# PERMIT

SEWAGE DISPOSAL SYSTEM  
MARYLAND STATE DEPARTMENT OF HEALTH

SUBDIVISION Beaufort Park ROAD 12389 Kondrup Drive LOT 8, Sec. 4

# SITE PLAN

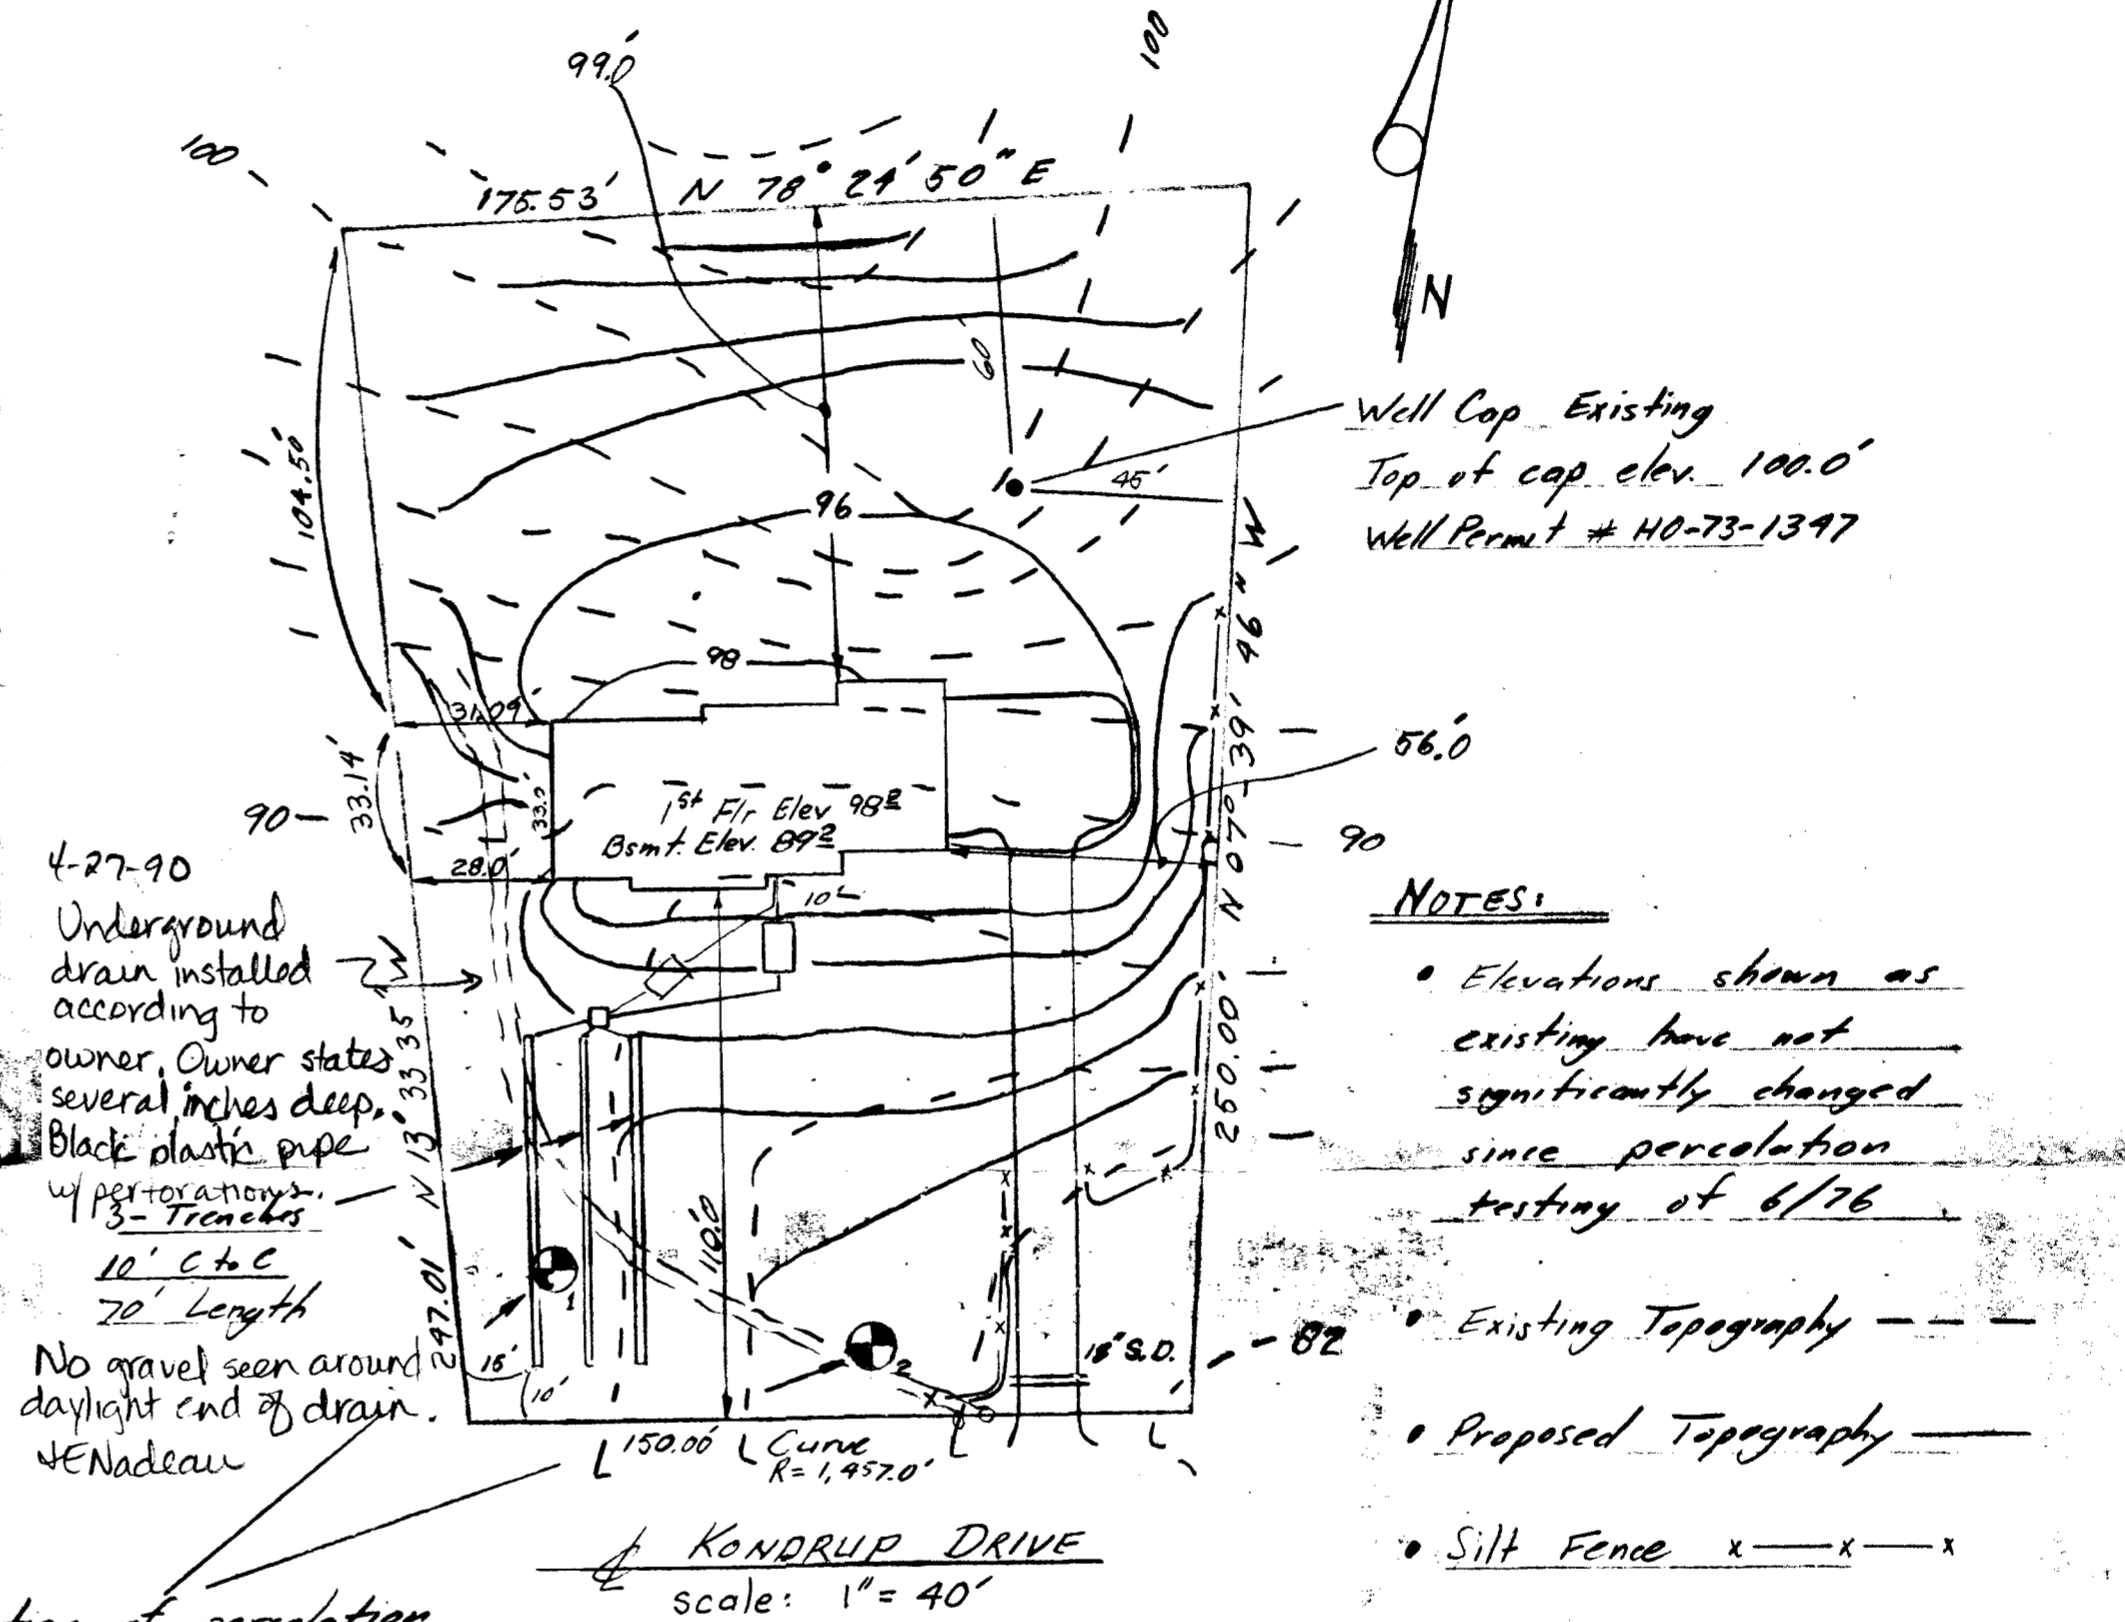
3/31/87  
elevation ok.  
S. Abel

3/31/87  
Location of septic  
area reasonable  
with known well  
site - 886

4-27-90  
Visited site and spoke to Mr. Jasper, some settlement around inlet end of septic tank. Also runoff drain installed several inches below grade which cuts over the top of the septic trenches and reserve area. Possibility that piping underground for storm runoff is acting as a conduit for soil around septic tank. Recommend he construct a barrier to reroute runoff from front patio and fill hole at septic tank with clean fill. JEN
